Erratum

Sustainability Statement Volume 1: main report of the Appraisal of Sustainability

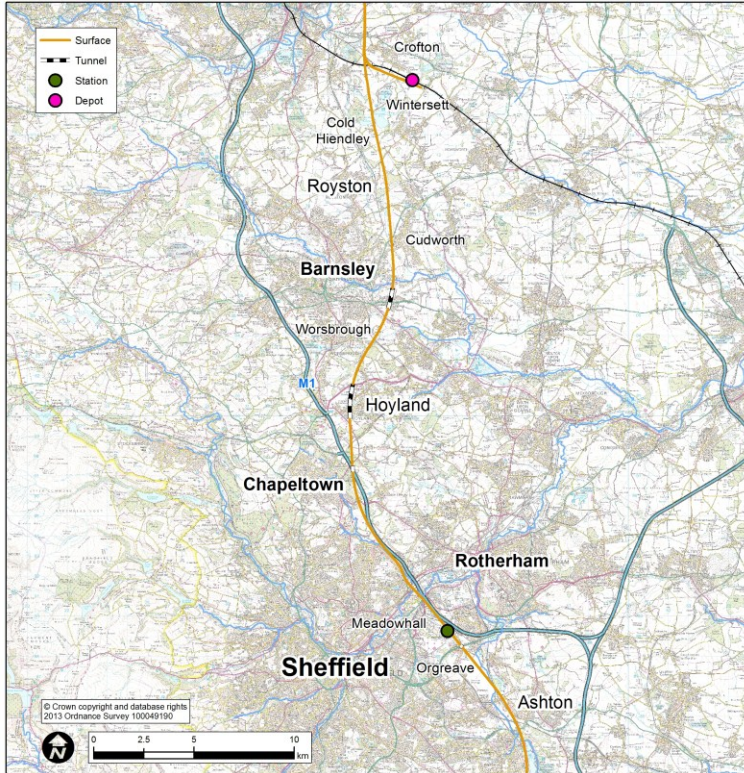
Page 24 - The image, ref 2-7 Eastern leg: Sheffield to Winterset, should be replaced with:
